Title: Modules

File: Modules Schematic.SchDoc

Data Processor Board

PWR IO Expander

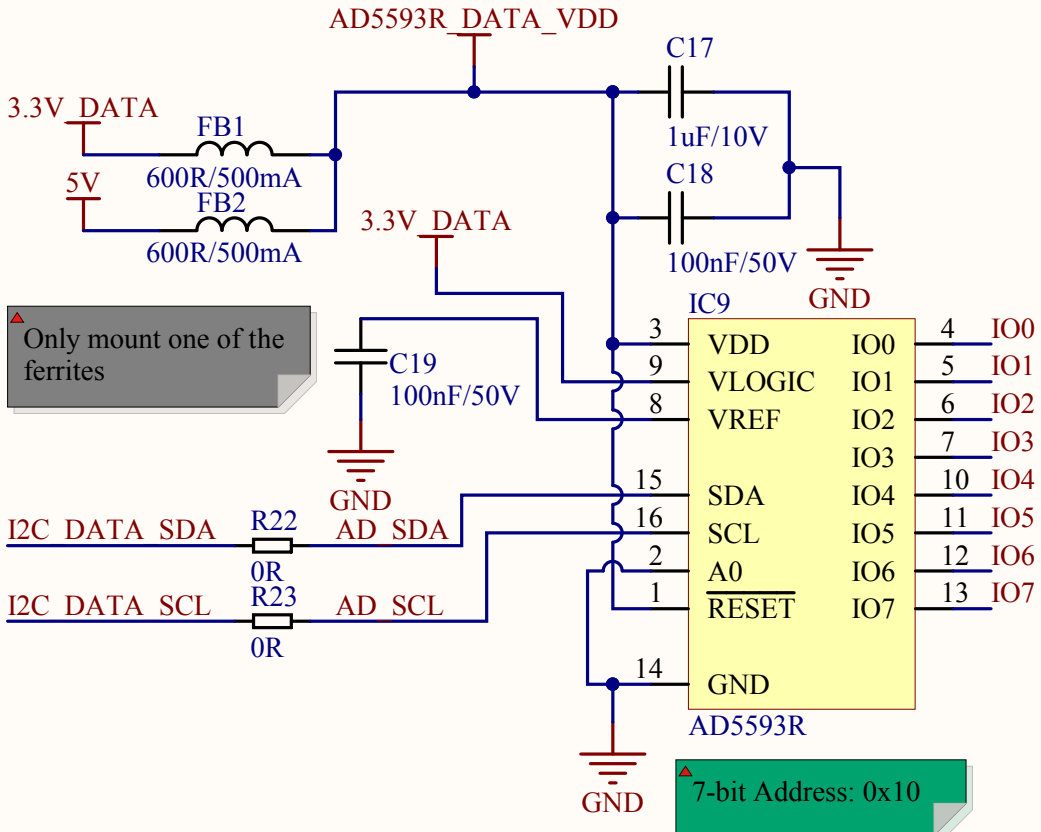
Replace PCF8574 with other expander. PCF8574 only has a weak pull-up which can't pull the PWR_n lines HIGH when there is a pull-down resistor on them. Solved by removing the resistor.
